DREAM PLACE SUBDIVISION

APPLICATION NUMBER 6 DATE February 16, 2006

REQUEST Subdivision

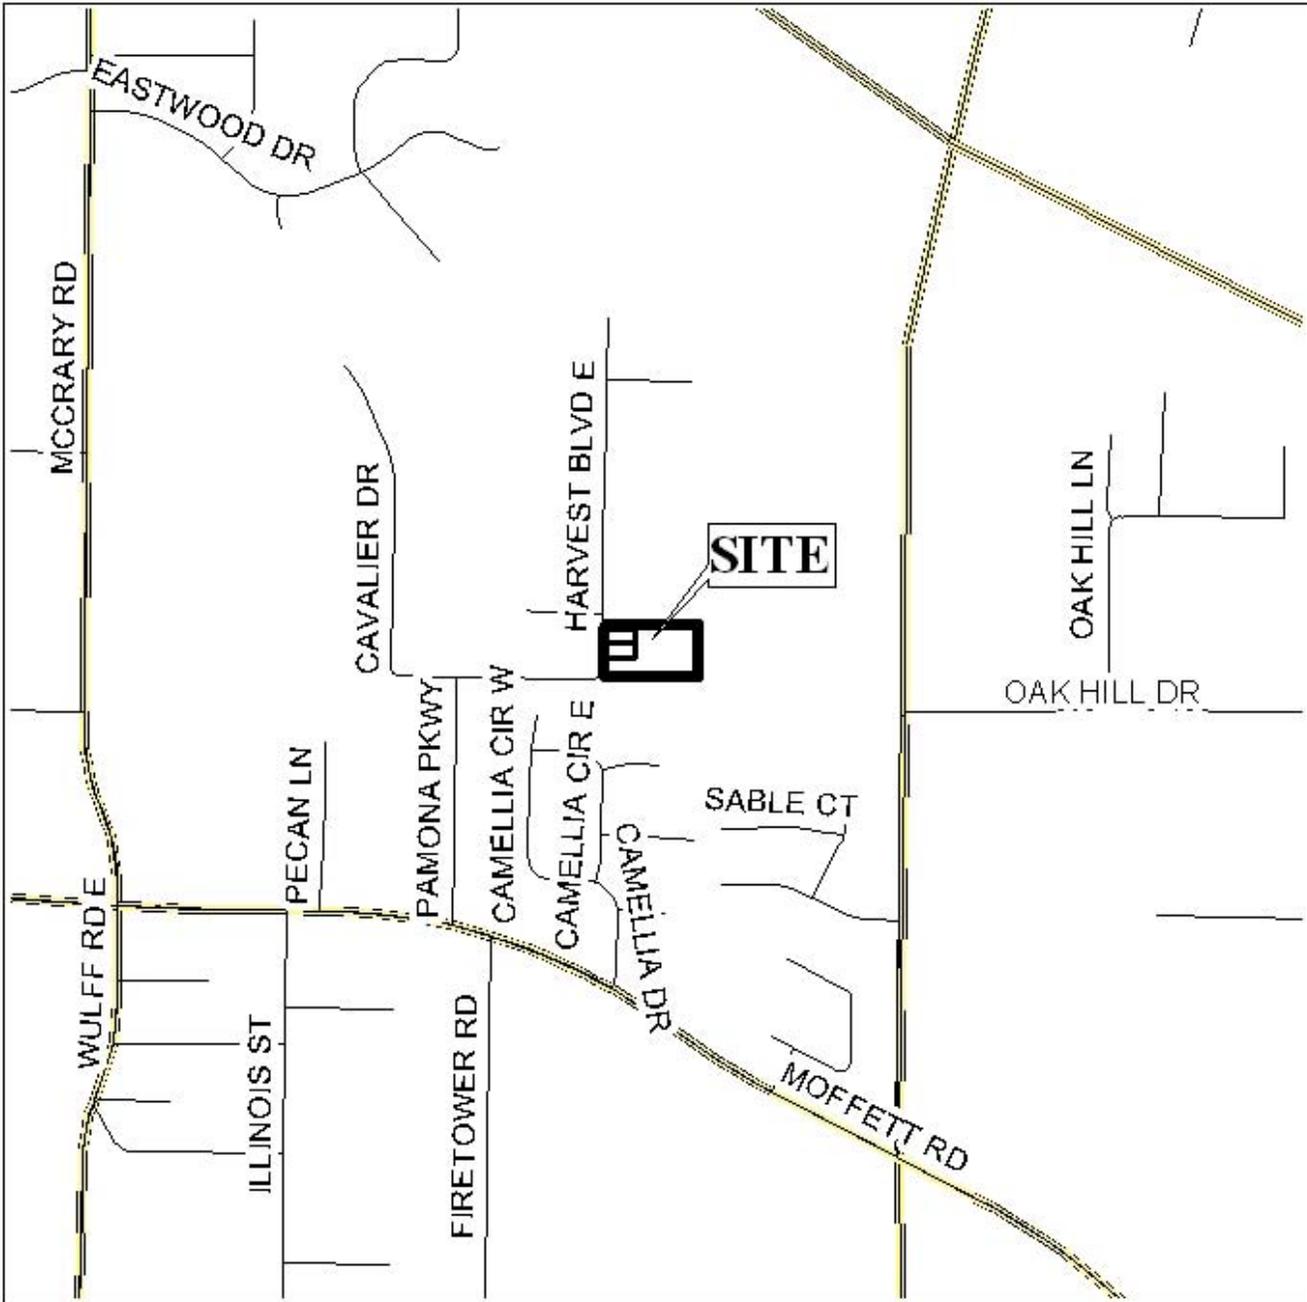
The plat illustrates two smaller lots of 19,600 square feet, and a larger lot of approximately 3.3 acres. The larger lot (Lot 3) has approximately 118 feet of frontage along a portion of Harvest Boulevard East, and a separate 25-foot flag-shaped access at the northwest corner.

The plat illustrates a 25-foot unopened right-of-way for the continuation of Harvest Boulevard North eastward, which had been referred to in a deed; however, no such right-of-way could be found in County records. As the Subdivision Regulations do not allow the dedication of half streets (Section V.B.10), this strip of land should be included in the parcel. The applicant's engineer has agreed with this determination and will provide revised plats including the property.

The flag-shaped nature of Lot 3 is problematic, in that it suggests the possibility of future resubdivision of the lot in a manner that would not be consistent with Section V.D.1 of the Subdivision Regulations, which states: "*The size, width, depth, shape, and orientation of lots and the minimum building setbacks lines shall be appropriate to the location of the subdivision and the type of development and use contemplated.*" While there is a flag-shaped lot approximately 300 feet North of the site, this is not characteristic of the area, nor does it appear to be necessary for the present application.

The plat meets the minimum requirements of the Subdivision Regulations and is recommended for Tentative Approval, subject to the following conditions: 1) the reconfiguration of the plat to eliminate the half-street and the flag-shaped appendage of Lot 3; and 2) the placement of a note on the final plat stating that any lots that are developed commercially and adjoin residentially developed property must provide a buffer, in compliance with Section V.A.7 of the Subdivision Regulations.
